**RE: DUPLEXES AT 433-439 TENNESSEE NE (K19-D111). ENGINEER'S
CERTIFICATION FOR CERTIFICATE OF OCCUPANCY APPROVAL.
ENGINEER'S CERTIFICATION DATED 12-23-96.**

**RE: DUPLEXES AT 433-439 TENNESSEE NE (K19-D111). DRAINAGE AND
GRADING PLAN SUBMITTAL FOR BUILDING PERMIT APPROVAL.
ENGINEER'S STAMP DATED 2-29-96.**

**RE: DUPLEXES AT 433-439 TENNESSEE NE (K19-D111). DRAINAGE AND GRADING
PLAN SUBMITTAL FOR BUILDING PERMIT APPROVAL. ENGINEER'S STAMP
DATED 2-13-96.**

DUPLICES AT 433-439 TENNESSEE N.E. GRADING, LANDSCAPING & DRAINAGE PLAN

DRAINAGE AND GRADING PLAN

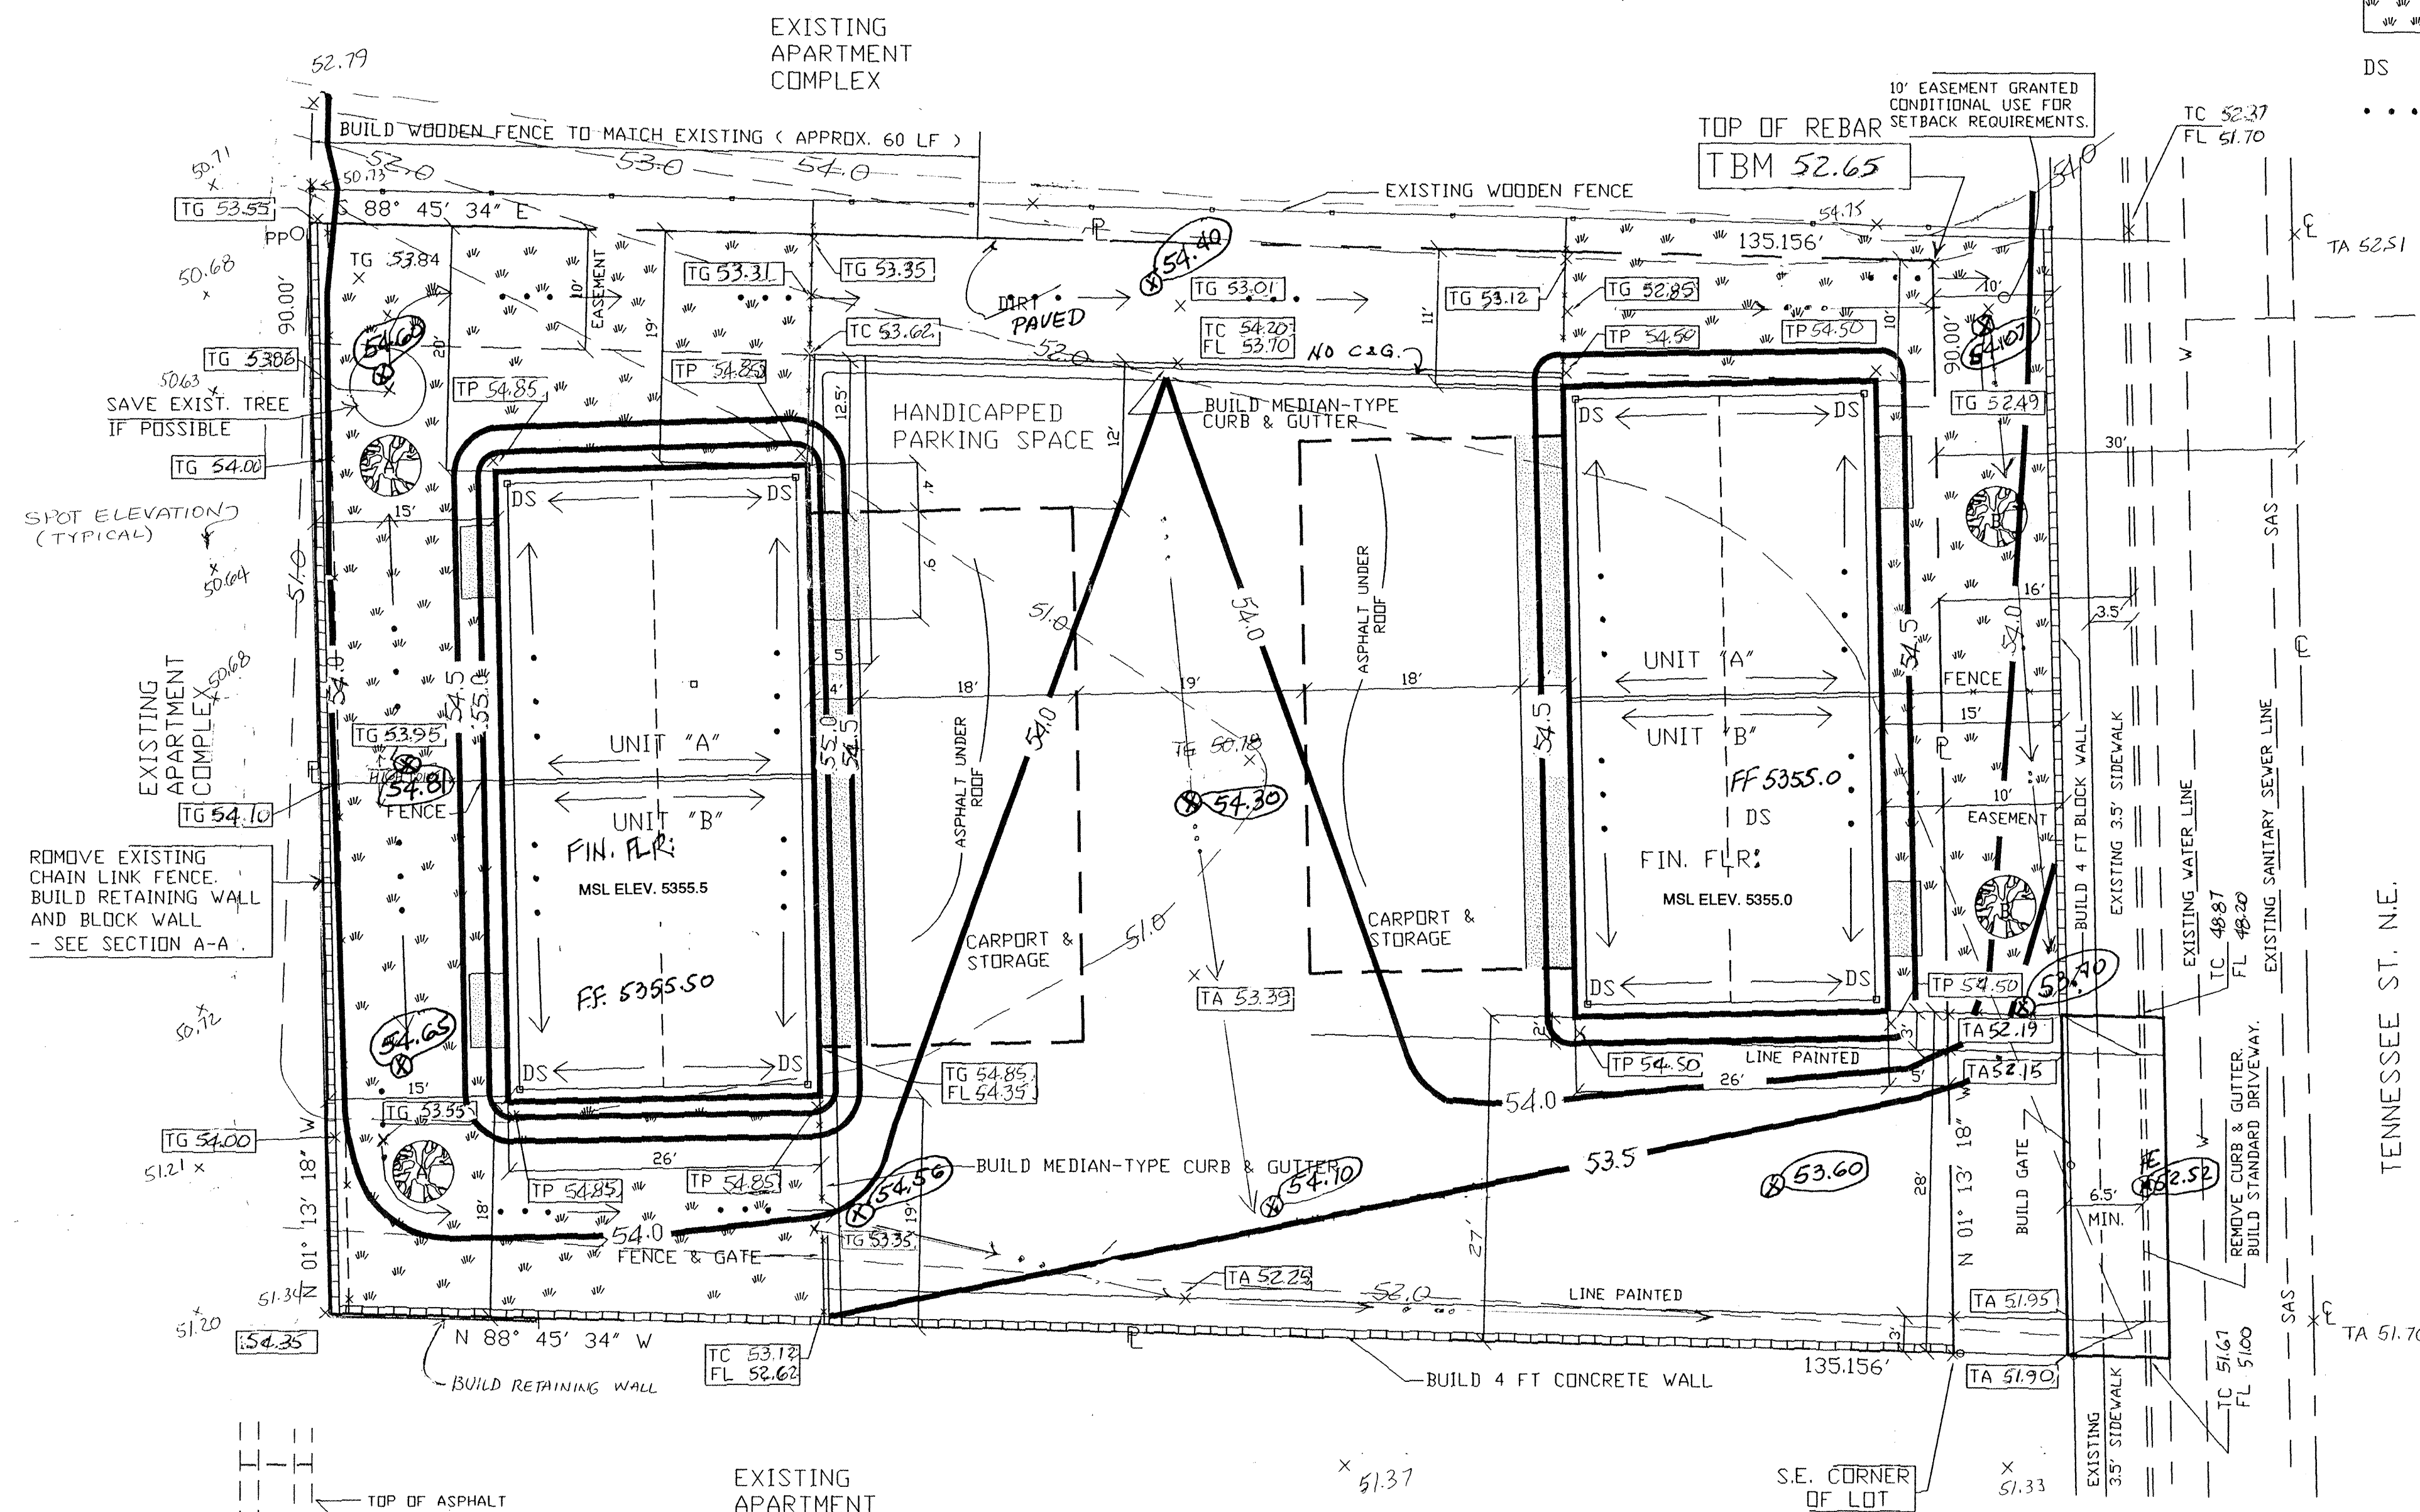
It has been brought to my attention that the grades on the above referenced project are from an assumed datum. When I approved this plan, I presumed that since you showed the finish floor to mean sea level, the spot elevations were referenced to the same Albuquerque control datum.

When you submit an Engineer's Certification, please be certain to reference all elevations from an established bench mark, an assumed bench mark is not acceptable.

1. Please show roof drain locations and/or direction of roof run off.
2. It appears that the north and west sides of the site are retaining water. Without information on the direction of roof flows, I can not tell whether these are landscaping ponds or retaining ponds. Retaining ponds are not allowed. If you want to use landscaping ponds, please provide pond volume calculations. Keep in mind that your finish floor elevations must be a minimum of 1 foot above your maximum water surface elevation.

3. Please show existing contours extending at least 25 feet beyond the property line.
4. Under the heading **CALCULATIONS** on your plan sheet, you show 100% land treatment "A" and 31% and 69% land treatments "B" and "D" respectively. This adds up to a total of 200%. Is some of this existing and some proposed? Please clarify.

5. Please show finish floor elevations to mean sea level.
6. Bench mark information must be shown on plan sheet.
